工程指示 / 要求簡箋(E.I.)

工程指示編號：EI / 1783 / 20

工程名稱：觀塘裕民坊

工程項目：Glass Cladding 後加玻璃面飾線 地盤用配件

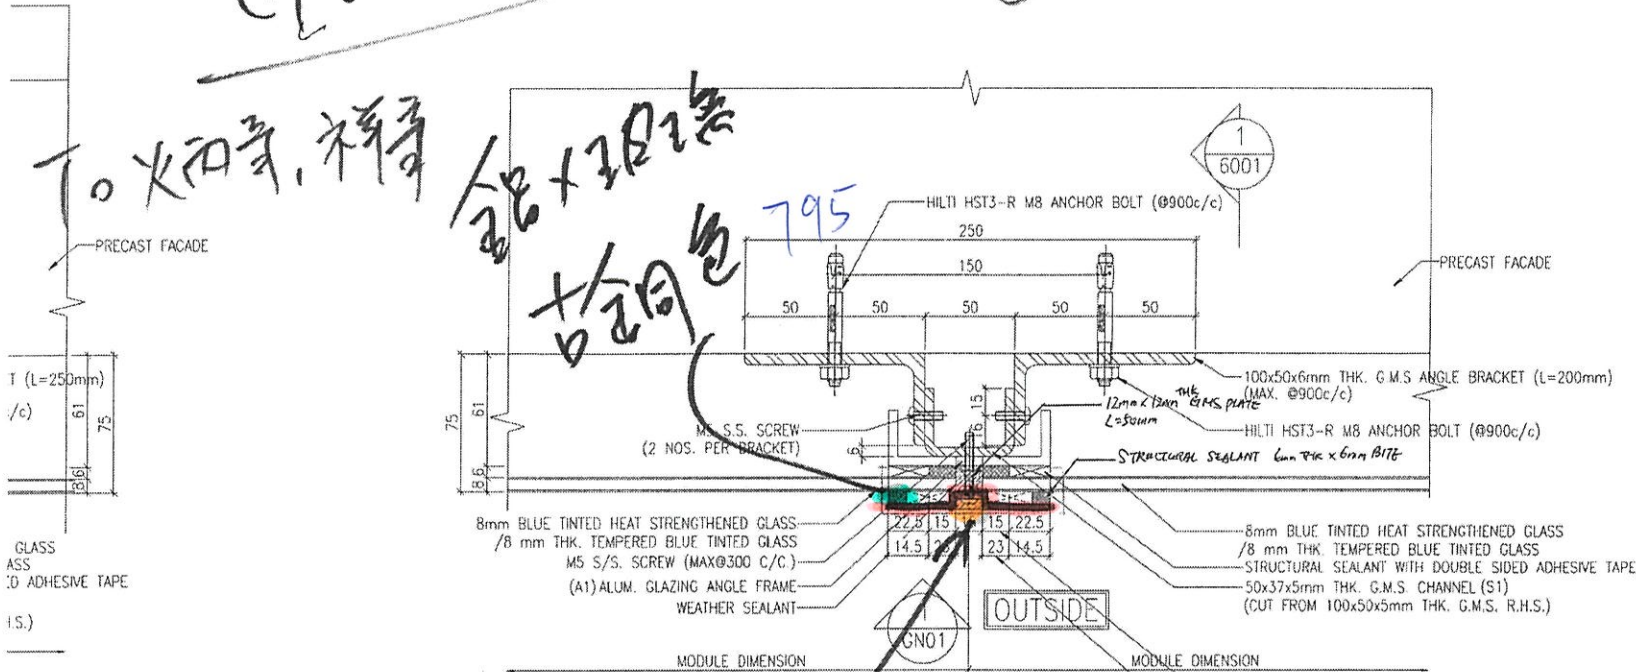
請按 BM 訂購配件送地盤使用

① 按地盤現場試裝飾線，需用 M5.5x32mm 圓頭自鑽螺絲

② 請留意膠位及膠包
